**BRIEF NOTE ON**  
**POSSIBILITY OF PRE-TSUNAMI SEISMIC DAMAGE AT**  
**FUKUSHIMA DAIICHI**

**CLIENT: GREENPEACE GERMANY**

**REPORT REF R3202-A1.DOCX**

**JOHN H LARGE**

## UNIT 2 ACCELEROMETER RECORD OF THE 11 MARCH 2011 EARTHQUAKE - TEPCO

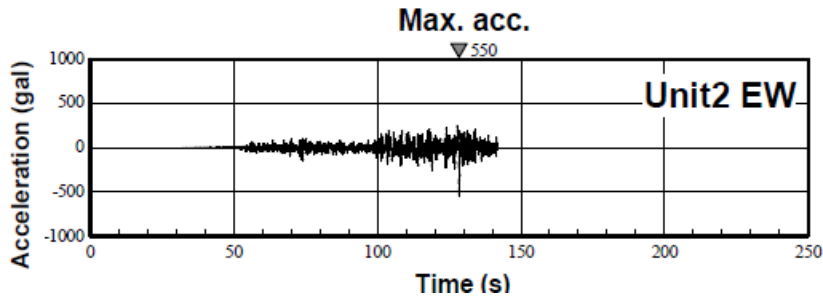
Of interest in the above tabulation are comparisons between the actual horizontal accelerations (NS and EW - 1<sup>st</sup> group in **RED**) recorded on 11 March 2011 to, first, the revised seismic qualification of 2008 (Ss mid columns) and, second, the original seismic design basis (right-hand columns). On 11 March, NPP Units 2, 3 and 5 were each subject to maximum accelerations that exceeded the 2008 seismic qualification (Ss) by about 20%,<sup>3</sup> although the exceedance is much greater (up to x2.2) the original design basis for horizontal ground motion.

So, obviously, the 11 March earthquake local effects at Fukushima Daiichi were greater than the 2008 seismic assessment of the Fukushima Daiichi site, meaning that the TEPCO 2008 requalification grossly underestimated to the potential seismic forces nominated for the Fukushima Daiichi site (the Ss value). In fact, it is not at all clear as to the extent and nature of physical work and plant modification that was actually undertaken by TEPCO for the 2008 seismic qualification upgrade – the IAEA fact finding mission of May-June 2011 clearly states that ‘*only some upgrading on piping supports was performed*’ and that ‘*no detailed information was provided [by TEPCO or NISA] regarding the physical upgrades [that were] effectively executed*’ ([IAEA](#) – p 70).
